# Access Compliance Report

## Public Rights-of-Way

### (Curb Ramps)

Intersection ID: 43362	Main Street: PROSPERITY_VIEW_DR	Cross Street: RIDGE_RD	Location: NE
ADA ID: C309C56573AF	Ramp Type: Perp	Initial Pass/Fail: Fail	Overall Compliance: No
Severity Score: 18.75			
Codes/Mitigation Info/Possible Solution		Field Measurements/Component Compliance

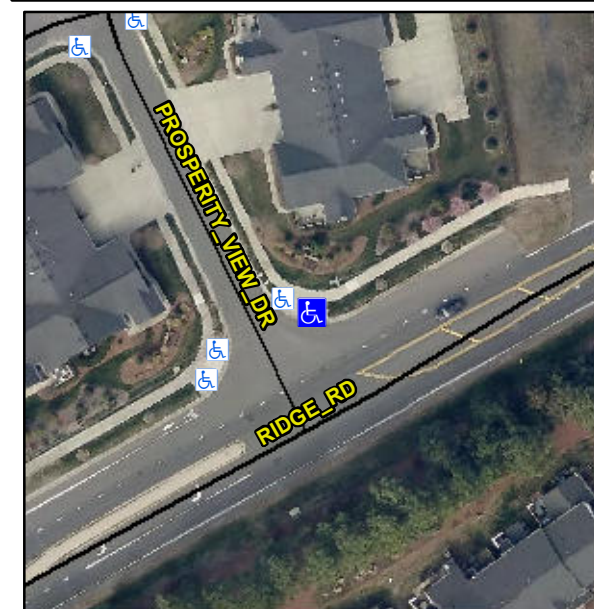
**Remove & Replace Entire Ramp.**

**R304.5.1, R304.5.3**

Compliance	Description	Data	Compliance	Description	Data
N/A	Ramp Length (in)	100.0	Yes	Ramp Slope (%)	7.5
No	Ramp Width (in)	35.5	No	Ramp XSlope (%)	2.1
N/A	Flare Type LT	N/A	N/A	Flare Type RT	N/A
N/A	Flare Slope LT (%)	N/A	N/A	Flare Slope RT (%)	N/A
N/A	Flare Traversable LT?	N/A	N/A	Flare Traversable RT?	N/A
N/A	Landing Length (in)	N/A	N/A	DWS Provided?	N/A
N/A	Landing Width (in)	N/A	N/A	DWS Contrast?	N/A
N/A	Landing Slope (%)	N/A	N/A	DWS Length (in)	N/A
N/A	Landing X Slope (%)	N/A	N/A	DWS Full Width?	N/A
N/A	Landing Curb? (Y/N)	N/A	N/A	DWS Offset (in)	N/A
N/A	Shared Landing?	N/A			
N/A	Gutter Ponding?	N/A	N/A	Gutter Slope (%)	N/A
N/A	Gutter Lip Ht (in)	N/A	N/A	Gutter X Slope (%)	N/A
N/A	Painted X Walk1?	No	N/A	Painted X Walk2?	N/A
	X Walk 1 Direction	To S		X Walk 2 Direction	N/A
N/A	X Walk 1 Width (in)	N/A	N/A	X Walk 2 Width (in)	N/A
	X Walk 1 Slope (%)	1.7		X Walk 2 Slope (%)	N/A
	X Walk 1 X Slope (%)	0.9		X Walk 2 X Slope (%)	N/A
